APPEAL OF PLANNING COMMISSION DECISION TO APPROVE QUAIL MEADOWS APARTMENTS

Case #MULTI-003751-2020; DR-003759-2020 & CDP-003761-2020

Encinitas Citizens for Responsible Development

Excerpt from Existing Conditions Slope Analysis by Lot Retrieved from original application for MULTI-003751-2020. Also provided as Exhibit 11

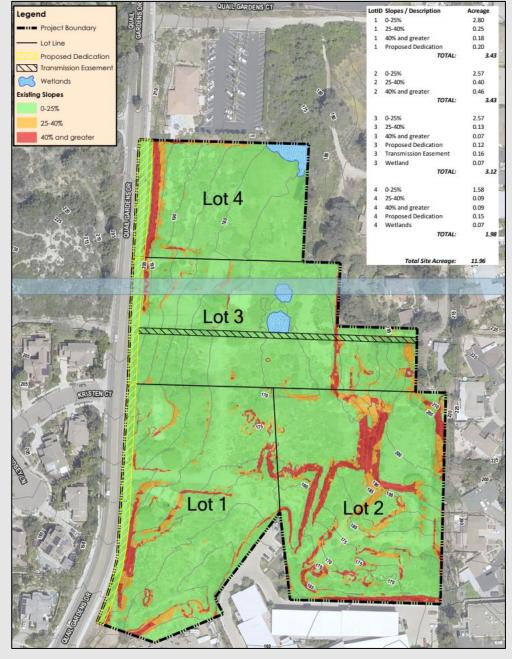
- EMC regarding Hillside
 Overlay Zone is not limited to undisturbed slopes
- Analysis inconsistent with requirements under EMC §30.34.030(B)(1)

All steep slopes on the project site are subject to the Hillside/Overlay Zone ordinances.

Buildable area calculations are inflated.
